Department of
Resources Recycling and Recovery

Subject: Review of the November 26, 2024, Revised Soil Reaction Break/Barrier Plan for the Chiquita Canyon Landfill Subsurface Elevated Temperature (SET) Event

Technical Memorandum from Dr. Stark dated February 26, 2025

RE: Comments on November 26, 2024 Revised Soil Reaction Break/Barrier Plan and February 20, 2025 waste temperature data for Chiquita Canyon Landfill Subsurface Elevated Temperature (SET) Event

Figure 1. Chiquita Canyon Landfill CO Range Map, March 8, 2025. (Source: SCSe Tools)

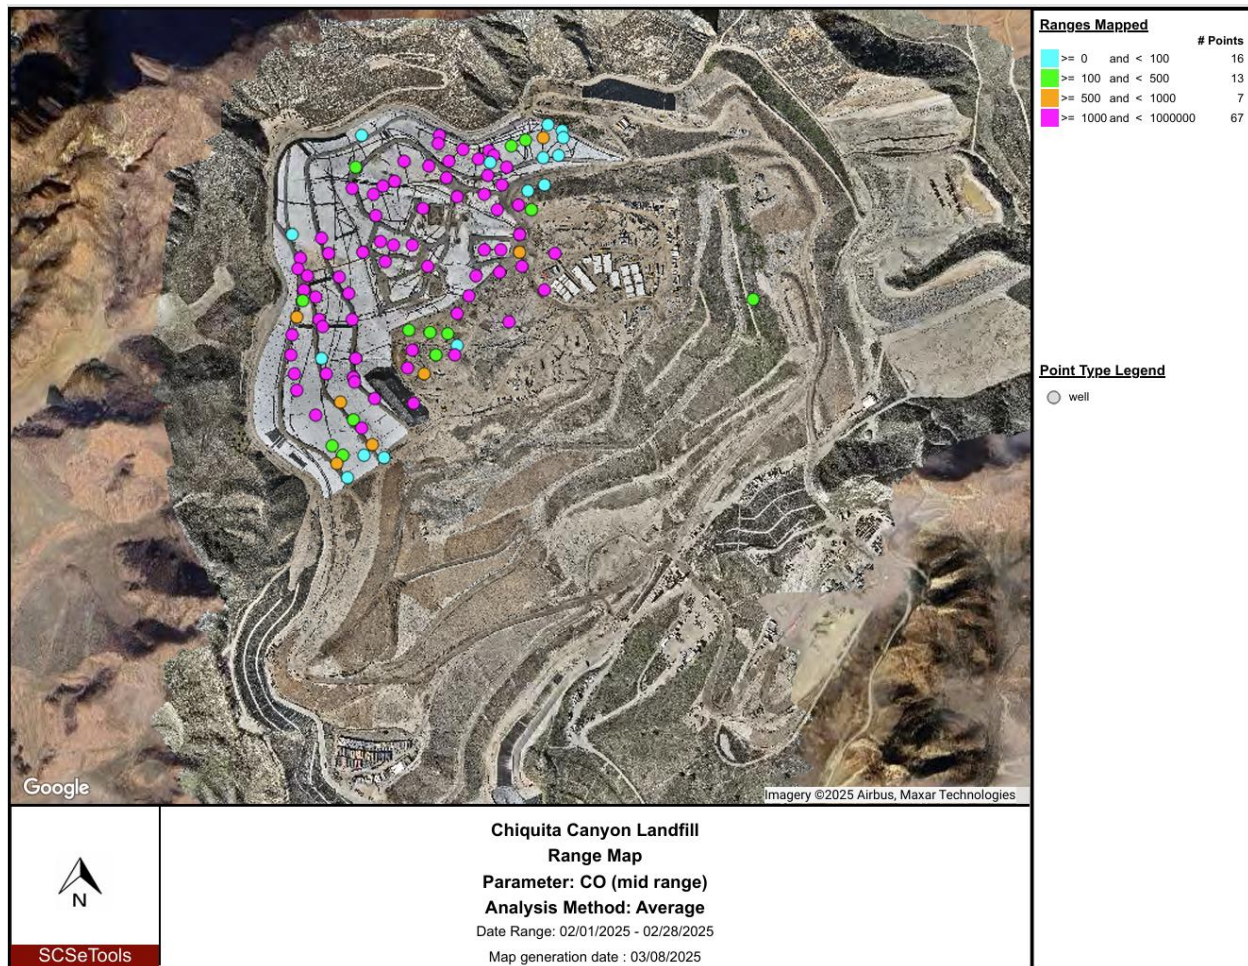
The Committee disregards the CO results, possibly because they assume this reaction is an unknown chemical reaction causing an ETLF event, rather than a smolder, SSO, or fire. Carbon monoxide concentrations have been used for over 40 years in the US and abroad as a measure to determine if a smoldering or SSO is extinguished. Carbon monoxide is also a sign of incomplete combustion, and the change of CO levels over time is a critical tool in determining the magnitude of the SET Event. This is also why USEPA requires CO measurements¹⁰ at a wellhead or any point in the well greater than 170°F (76.7°C). CalRecycle staff is aware that CCL is tracking CO and providing a scale for intensity in SCS Tool, but we are unsure why the Committee is disregarding a key metric. **Figure 1** provides the most current CO levels at the CCL.

Figure 2. TMP-14 Temperature Profile Demonstrating a Shallow SET Event Developing at Chiquita Canyon, April 24, 2024, to March 19, 2025. (Source: SCS Engineers TMP Data)

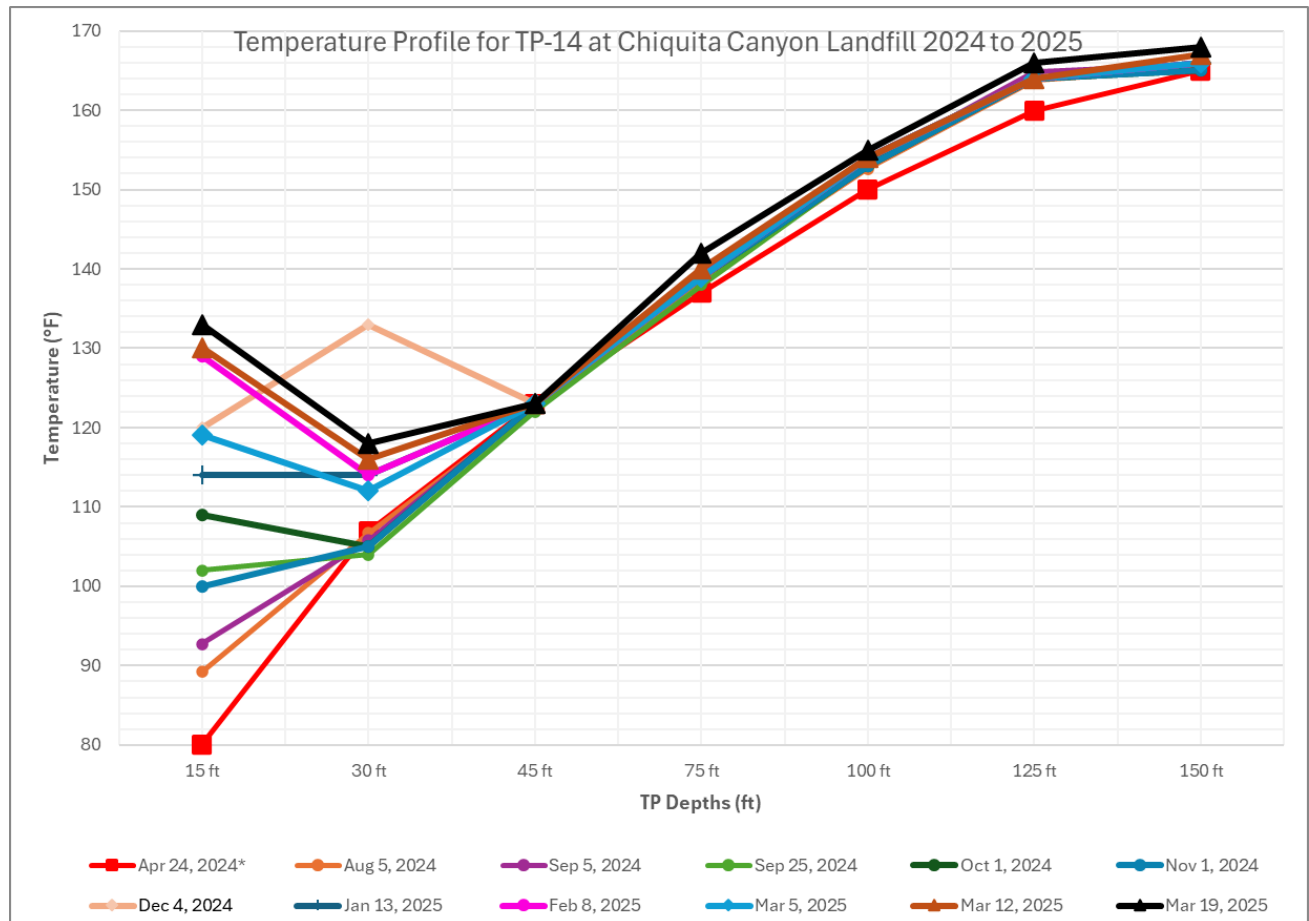
As an example of how wellhead temperatures can mask what is occurring in the waste, as shown in **Figure 2**, TMP-14 reported a temperature of 80°F (26.7 °C) on April 24, 2024, at the fifteen-foot probe. By March 19, 2024, the temperature at the 15-foot probe had increased to 133°F (56°C). This shallow temperature spike was not observed in gas well CV-1906, approximately 10 to 15 feet away, where the wellhead temperature was reported to be 68°F (20°C) on April 1, 2024, and 60°F (15.5°C) on March 19, 2025. There were also significant temperature swings in the wellhead temperature data for gas well CV-1906, where the temperature rose from 95°F (35°C) to 121°F (49°C) and then dropped to 73°F (22.7°C) within a month. However, all the wellhead temperatures are below the regulatory threshold and do not require further analysis. Data from TMP-14 indicated that on March 19, 2025, the temperature reached 133°F (56°C) and exceeded the 131°F (55 °C) threshold. CV-1906 is also experiencing a significant oxygen overdraw at this location. The percent oxygen has varied from 10.9 percent on March 4, 2024, to 18.7 percent on March 6, 2025. The average oxygen for the past year at this well is 8.4 percent. Continued high oxygen levels above 2 percent and temperature spikes will lead to a SET Event. This TMP and gas well are approximately 450 feet away from the CCL-defined reaction boundary and CalRecycle staff do not believe the shallow temperature increases are connected to the main reaction area. CalRecycle believes that the temperatures of 166 to 168°F (74.4 to 75.5°C) at the deeper probe (i.e., 125 to 150 ft) are connected. However, this data demonstrates that the operation of the GCCS must not sacrifice LFG operational objectives/standard operating procedures (i.e., limiting oxygen to 2 percent¹⁵) to control emissions and risk developing of new SET Events. **Table 2** and **Table 3** provide the LFG data and temperatures for gas well CV-1906 and TMP-14.

- TMP-14 is demonstrating a shallow SET Event.
- Temperatures in six TMPs (TP-6, TP-13, TP-14, TP-17, TP-19, TP-20) have been or are currently trending upwards since installation in April 2024.

Figure 5. Maximum Vertical Temperature Map for TMPs for Chiquita Canyon for 2025. (Source: SCS Engineers TMP Data March 2025)

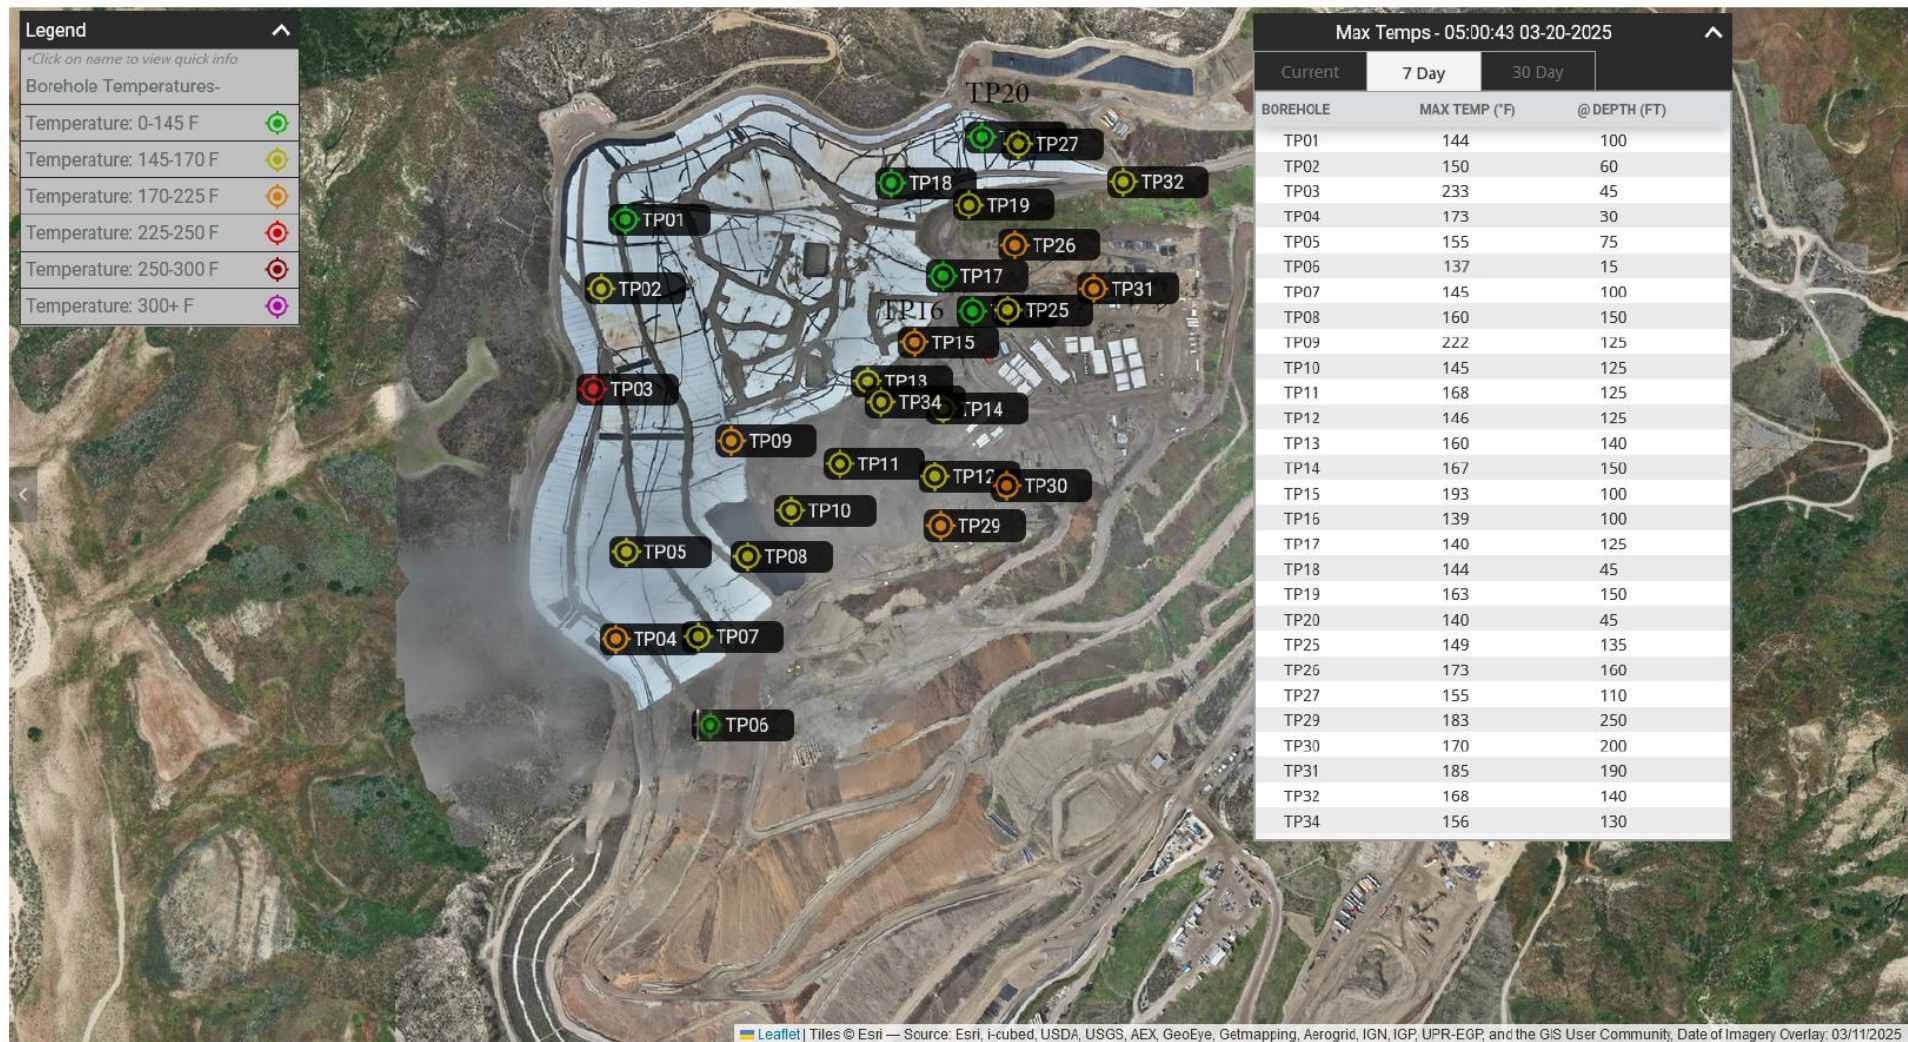
A review of the new temperature data from TMPs (TP-25, TP-26, TP-27, TP-29, TP-30, TP-31, TP-29, and TP-34) determined that all the temperatures in the new TMPs exceed the regulatory threshold of 145°F (62.8°C). Five TMPs (TP-26, TP-29, TP-30, TP-31, TP-32) have temperatures above 160°F (71.1°C), with the highest being TP-31 (with a temperature of 185°F (85°C) at a depth of 190 ft), located over 600 ft from the CCL-defined reaction boundary. It is also important to note that in January 2025, the CCL changed the probe depths of the new TMPs without notifying the LEA. The CCL elected to install the probes at 25, 40, and 50 ft instead of the approved design of 15, 30, and 45 ft. This change in probe depth will decrease the ability to track shallow SET Events. It is recommended that any future TMP be constructed in accordance with the approved plan. **Figure 5** provides the current maximum vertical temperature map for the TMPs at the CCL.

- Five new TMPs (TP-26, TP-29, TP-30, TP-31, TP-32) temperatures are above 160°F, with the highest being TP-31 with 185°F at 190ft below the surface. TP-31 is located over 600 ft away from the CCL-defined reaction boundary.

Figure 6. CCL Isopatch Settlement Map, January 3, 2025 Survey Image. October 2, 2024 vs January 3, 2025. (Source: CCL February 2025)

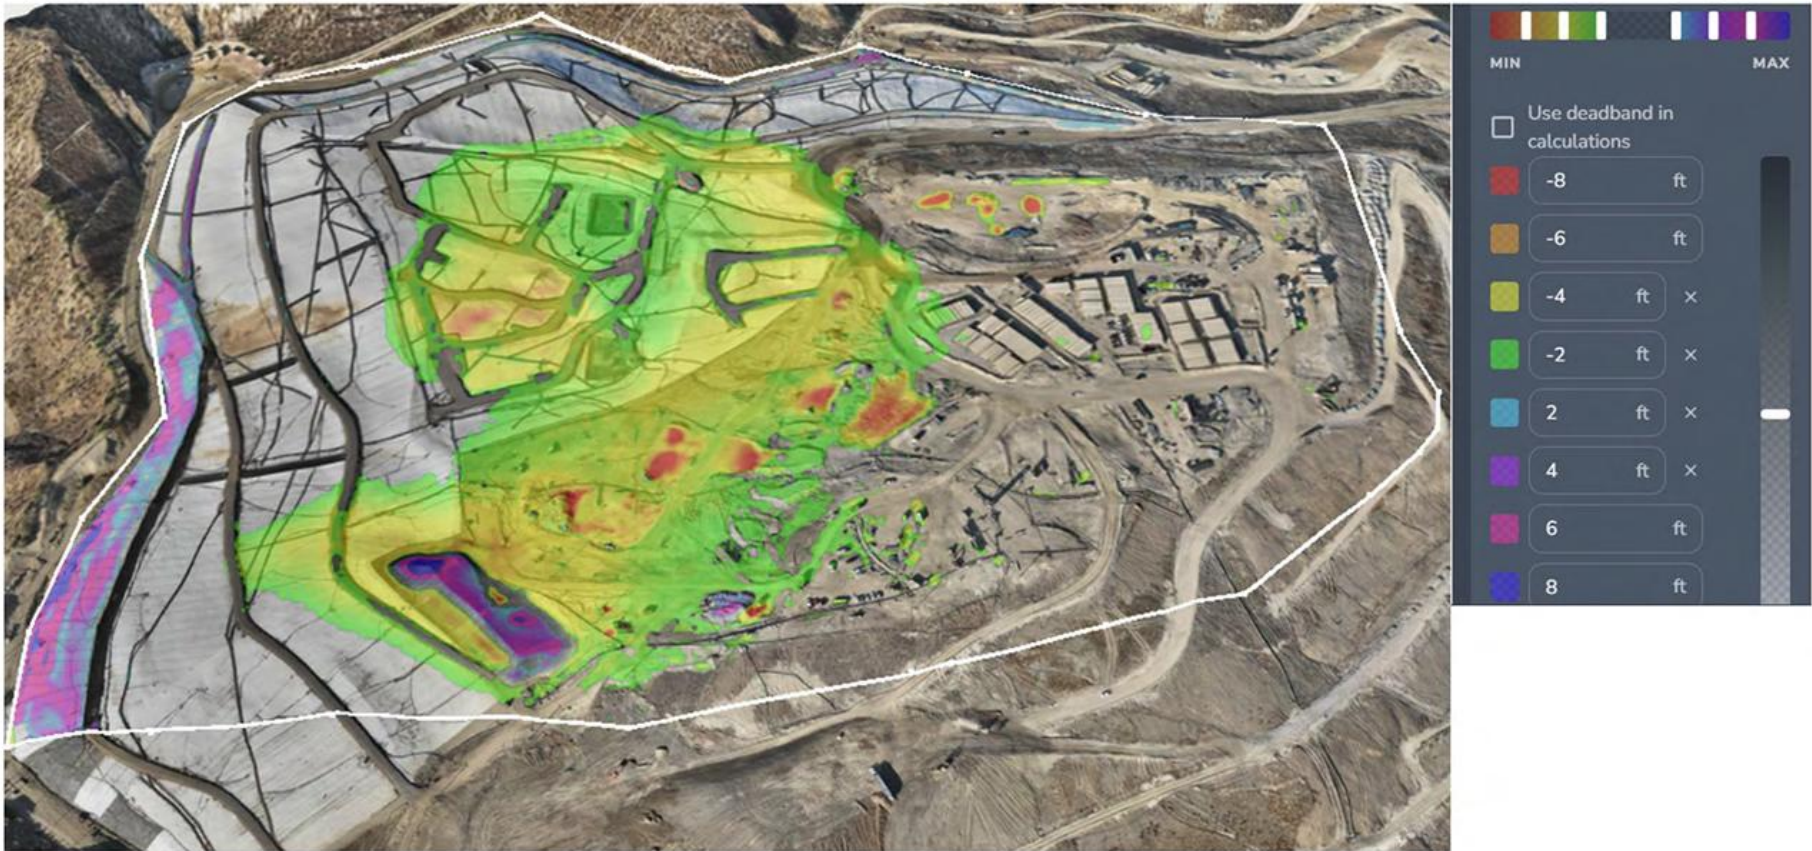
There are several ways to increase the degree of certainty in determining the magnitude of a SET Event. Without all the available data, the operator or regulator must evaluate primary indicators such as temperature, LFG gas data, CO, H₂, and physical signs of a SET Event. If other reports or data are available, the operator should analyze this data and compare it to the primary tool. Other data would include FLIR imagery with reference temperature scale, settlement, leachate and gas chemical characteristics, fissures, slope stability reports, additional temperatures from liquid pumps in wells, 2D and 3D temperature modeling, isopatch modeling, odors and emissions, leachate outbreaks and generation, and individual LGF gas plots. The CCL is using isopatch software to track the settlement every quarter as shown in **Figure 6**. They also track the

settlement bi-monthly in the Cover Inspection Reports. The maps show the settlement area growth of more than 5 feet. **Figure 7** shows the most current settlement map.

Figure 8. Fissure and Crack Monitoring Report for February 2025. (Source: Geo-Logic Associates)

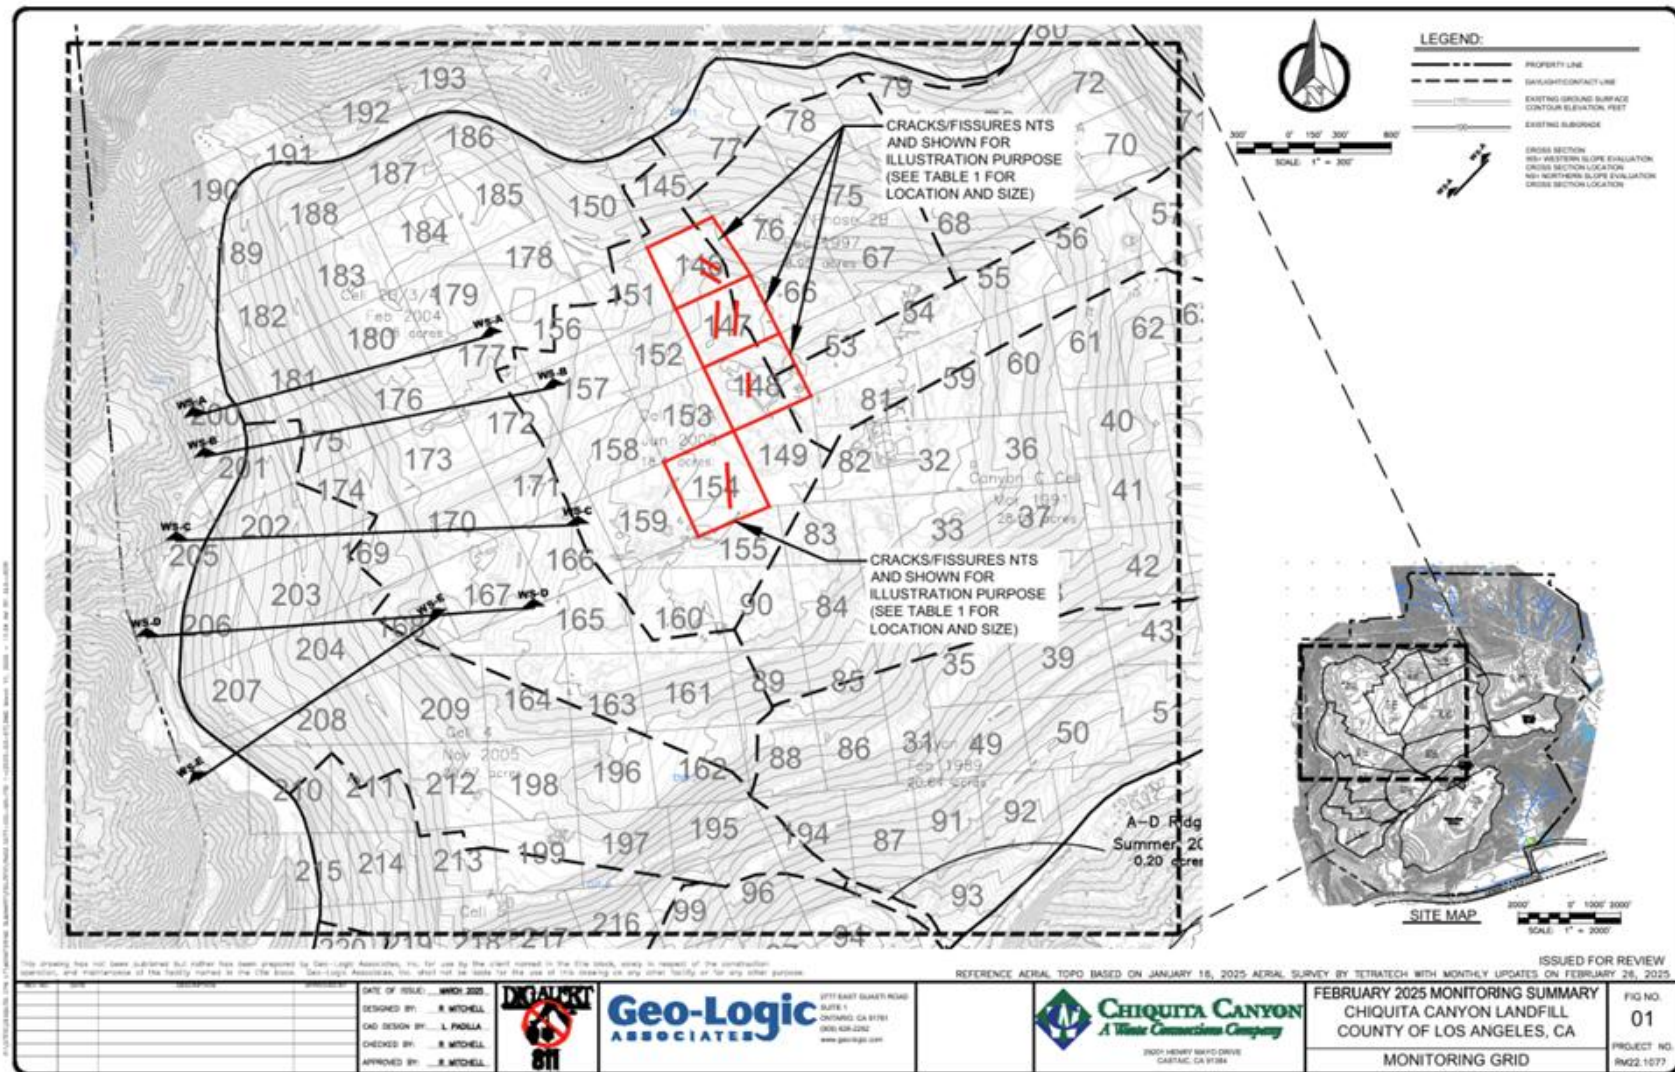
The CCL Settlement and Fissure Reports also align with the TMP temperature spikes data in grids. CCL's consultant, Geo-Logic Associates, provided a summary map of the recently occurring fissures in February 2025 (see **Figure 8**). Significant fissures and areas where the soil collapsed were documented in Grids 146, 147, 148, and 154. CalRecycle also reviewed FLIR data from October 2024; however, CCL has refused to provide the temperature layer on each photo. All data should be available.

Figure 1. Temperature profiles over six weeks from 1/9/2025 to 2/19/2025 from SCS report dated February 20, 2025.

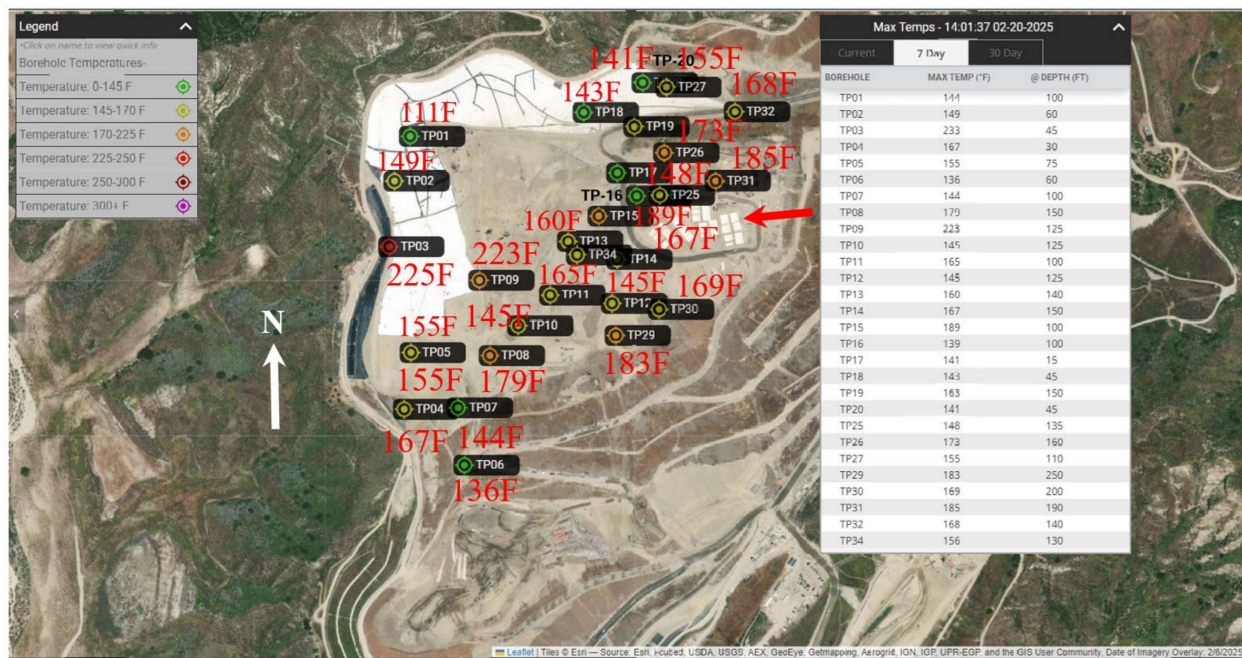
SCS presents Waste Borehole Maximum Temperature Profiles Over 6 Weeks from January 9, 2025 to February 19, 2025.⁶ An aerial image of CCL with a table of maximum temperatures is included in the subject SCS Report and reproduced in **Figure 1**. I have placed the maximum waste temperature from the table in **Figure 1** adjacent to some of the gas extraction wells to facilitate understanding the extent of the SET Event, especially on the east side of CCL. **Figure 1** shows waste temperatures of 183°F and 185°F at the eastern side of the top deck of the CCL. This means the SET Event has migrated from the western slope (TP03) to the eastern side of the CCL (TP31). Expansion of the SET Event has the following implications:

- Elevated temperatures (185°F to 189°F) surround the leachate tank farm (see red arrow in **Figure 1**). This area is going to undergo significant settlement, if it has not already started to do so, due to thermal breakdown of the buried waste. This settlement will cause differential movement of the leachate tanks, which could result in a leachate release. As a result, I recommend the leachate tank farm be moved off the top deck and to a site off the CCL and on native soil because the SET Event continues to expand.
